CLIENT:	Jones Homes (Yorkshire) Limited
PROJECT:	Land at Primrose Lane, Liversedge
SUBJECT:	Technical Response to Coal Authority Objection
JOB NO:	LD11032
DATE:	18 th September 2024
PREPARED BY:	Jonathan Currie (Wardell Armstrong, Associate Director)
CHECKED BY:	Abdul Rehman (Wardell Armstrong, Regional Director)

This Technical Note (TN) has been prepared by Wardell Armstrong (WA) to address the substantive concerns raised by the Coal Authority (CA) pursuant to Local Planning Authority number 2023/62/91116/E for the proposed development of 77 dwellings at land off Primrose Lane, Hightown, Liversedge (the Site).

PROJECT	LAND OFF PRIMROSE LANE, LIVERSEDGE			
DRAWING TITLE	MINE SHAFT ZONE OF INFLUENCE DRAWING			
DRG No.	LD11032-001	REV	P02	SUFT. CODE
DRG SIZE	A1	SCALE	1:500	DATE
DRAWN BY	MC	CHECKED BY	JC	APPROVED BY
				22.07.24

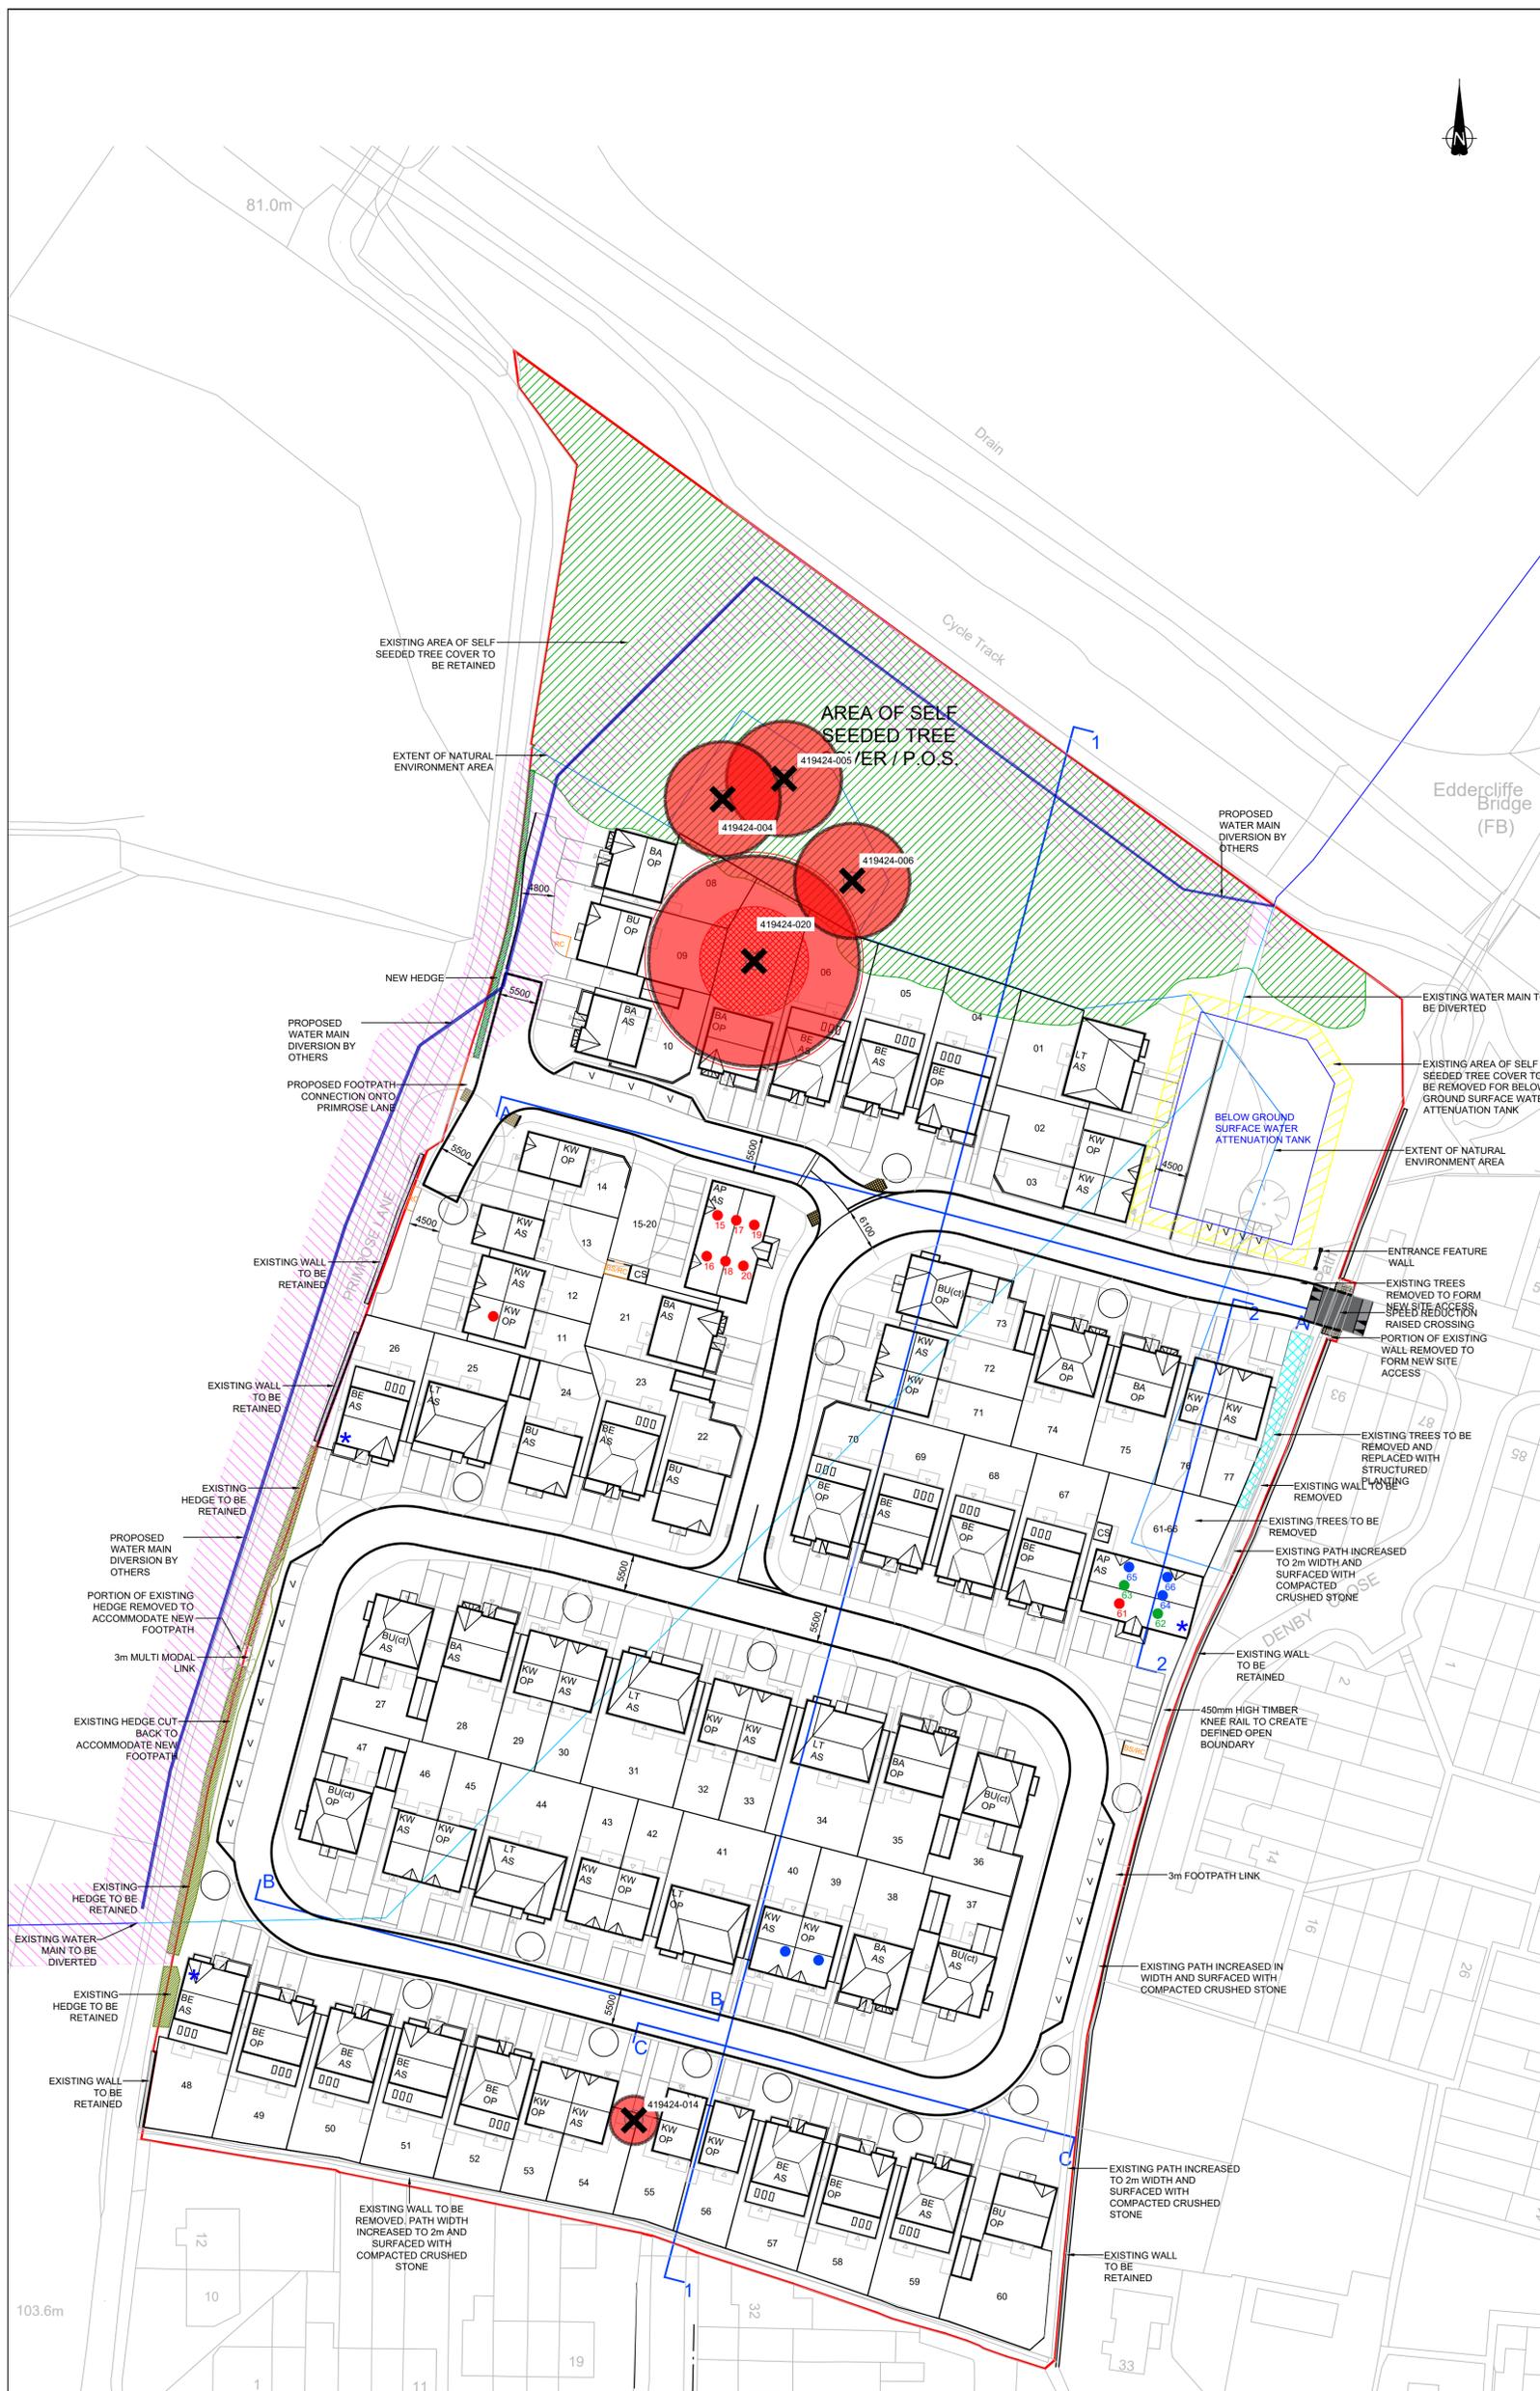
The CA's objection, as detailed in their response dated 5th July 2023, primarily relates to concerns that the proposed development layout has not been sufficiently informed by the presence of the mine shafts and their potential zones of influence (ZOI). Other key issues that were raised included the potential for shallow, unrecorded coal mining activity beneath the Site, which may lead to voids, ground instability, and the risk of mine gas emissions.

It was advised that further intrusive investigations would be required to locate all the recorded mine entries within the Site, including establishing the adequacy of any past treatment works. The findings should then be used to revise the proposed development layout to ensure that the built development avoids the mine shafts and their associated ZOI's.

Drawing LD11032-001 shows that the mine entries 419424-004, 005, 006 and their ZOI are located outside of the built development area. Furthermore the Yorkshire Water Main Diversion has been rerouted to avoid these mine entries. Given that the shafts are now located within an undeveloped area, the area is to remain woodland and that the shafts are capped and treated, these mine entries pose a very low risk to the proposed development.

Drawing LD11032-001 shows that this mine entry and its ZOI are no longer located beneath a building and are now restricted to the garden areas of Plots 54 and 55. While the mine entry and its ZOI are still located close to residential dwellings, several factors significantly reduce the likelihood of any major instability.

Drawing LD11032-001 shows that the mine entry is located within garden area of Plot 07 and the proposed development has been amended so that the majority of the ZOI is now restricted to the garden areas of Plots 06 – 10. While Plots 06 and 07 are still located within the wider ZOI, the proposed development has been carefully amended to ensure that they are not located within this mine entries departure radius.
